Access Compliance Report Public Rights-of-Way (Curb Ramps)

Main Street: CHARDONNAY_DR Cross Street: REGENT_PARK Location: SW

ADA ID: RPAT211103133616 Ramp Type: Type 1 - Perpendicular Diagonal Initial Pass/Fail: Pass Overall Compliance: No Severity Score: 22

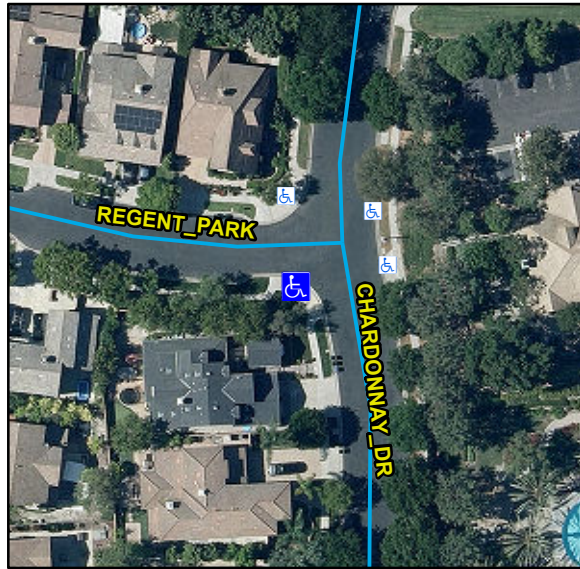
Compliance	Description	Data	Compliance	Description	Data
N/A	Ramp Length (in)	98	N/A	Flare Type LT	
Yes	Ramp Width (in)	48			Sloped
Yes	Ramp Run Slope (%)	3.8	Yes	Flare Slope LT (%)	4.5
Yes	Ramp Cross Slope (%)	0.5	N/A	Flare Traversable LT	Yes
N/A	Landing Present	No	N/A	Flare Type RT	
N/A	Landing Length (in)	N/A			Sloped
No	Landing Width (in)	N/A	Yes	Flare Slope RT (%)	5
No	Landing Run Slope (%)	N/A	N/A	Flare Traversable RT	Yes
No	Landing Cross Slope (%)	N/A	No	DWS Provided	No
N/A	Landing Movement Obstructed?	Yes	N/A	DWS Contrast	N/A
	Landing Movement Type	Curb	N/A	DWS Length (in)	N/A
N/A	Landing Shared	N/A	N/A	DWS Full Width	N/A
N/A	Clear Space	Yes	N/A	DWS Offset Left (in)	N/A
N/A	Clear Space To Crosswalk (in)	48	N/A	DWS Offset Right (in)	N/A
N/A	Marked Crosswalk 1	No	N/A	Marked Crosswalk 2	No
	Crossing 1 Direction	E		Crossing 2 Direction	N
	Marked Crosswalk 1 Width (in)	N/A		Marked Crosswalk 2 Width (in)	N/A

N/A	Ramp Inside Crosswalk 1	N/A	Yes	Ramp Inside Crosswalk 2	N/A
	Crossing 1 Slope (%)	2.2		Crossing 2 Slope (%)	1.5
	Crossing 1 Cross Slope (%)	1		Crossing 2 Cross Slope (%)	0.2
Yes	Gutter Ponding	No	No	Curb Slope	11.3
Yes	Gutter Lip Height (in)	0		Road Run Slope (%)	0.4
Yes	Gutter Run Slope (%)	4.9		Road Cross Slope (%)	0.5
Yes	Gutter Cross Slope (%)	0.8			
Yes	Overall Surface Condition: Acceptable		No	Perp Joint Present	No
	Cross Gutter Present?	No		Spandrel Present?	No
	Replace Cross Gutter?	N/A		Replace Spandrel?	N/A

Possible Solutions:

Remove & Replace Curb Ramp With Two New Directional Ramps or Equivalent.
